**Proposal for amendments /  
corrigendum to UN GTR No. 4  
- Summary of correction -**

# Background and Contents of Proposal

- There are many discrepancy among the amendment version of UN GTR No. 4 and UN Regulation No. 49 which seems to be mistakes in drafting.
- Amendment is only for the correction of the mistake in technical descriptions.
- It is expected to be confirmed by the expert in each area and determined in next GRPE.

Figure 9  
Schematic flow diagram of raw exhaust gas analysis system for CO, CO<sub>2</sub>, NO<sub>x</sub>, HC

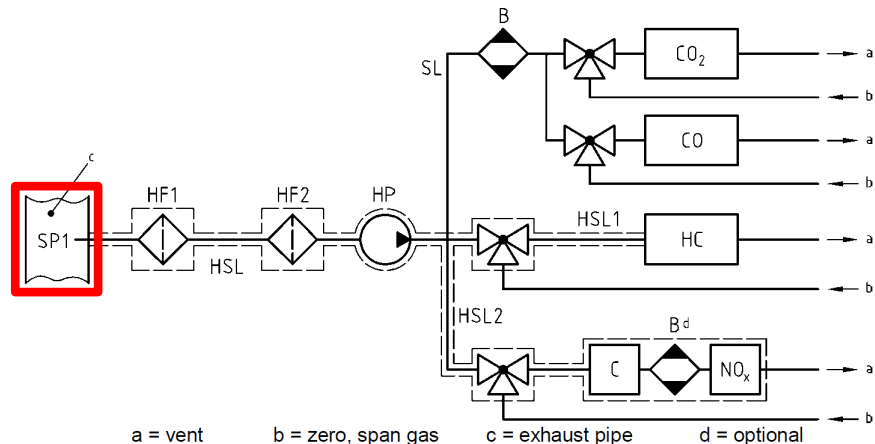
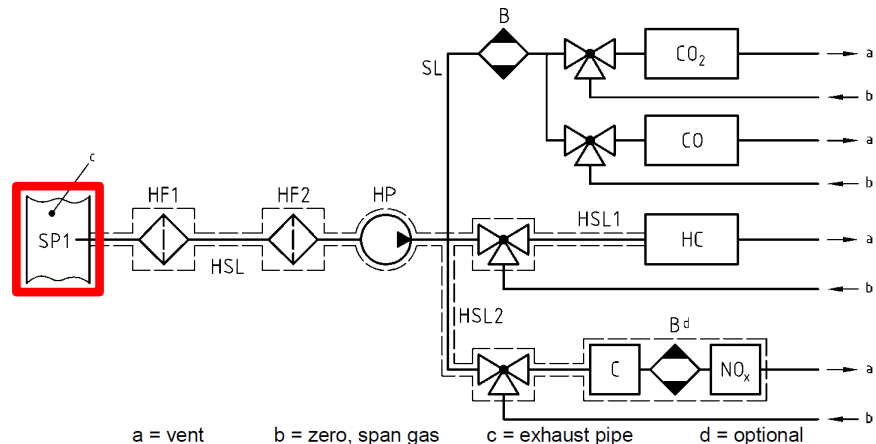
## A.3.1.3. Components of Figures 9 and 10

**SP** Raw exhaust gas sampling probe (Figure 9 only)

**SP1** Raw exhaust gas sampling probe (Figure 9 only)

Figure 12  
Scheme of partial flow dilution system (total sampling type)

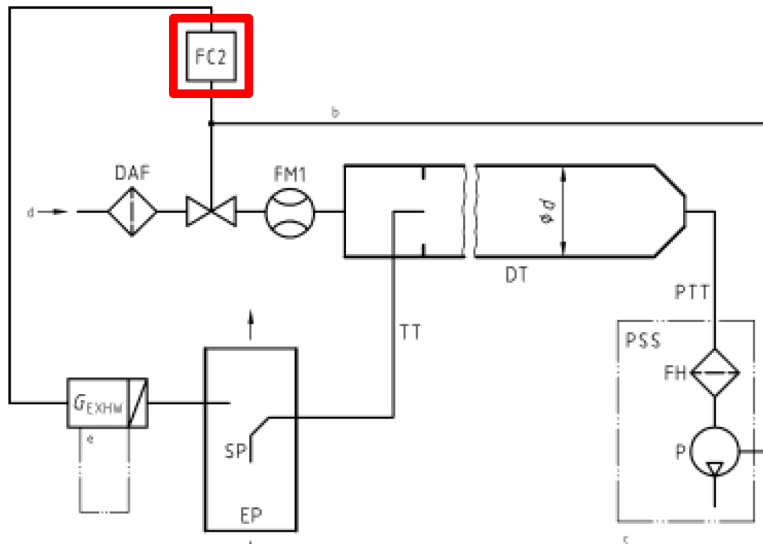
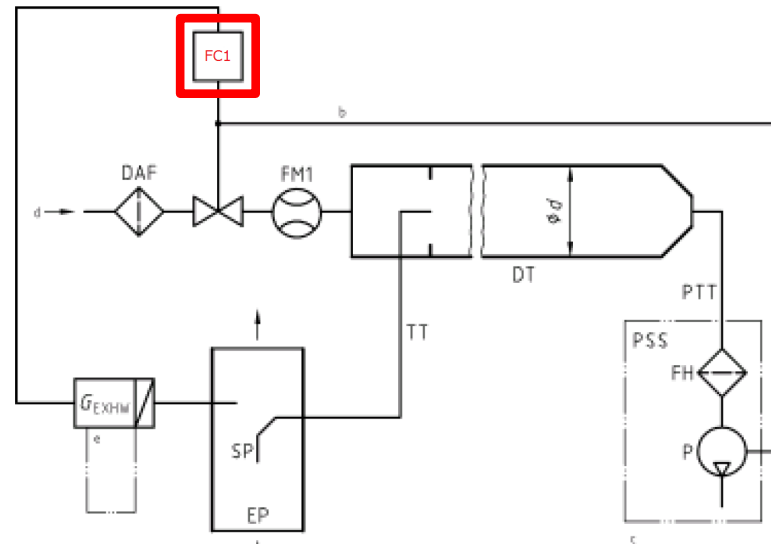
## A.3.2.1. Description of partial flow system -Figure 12-
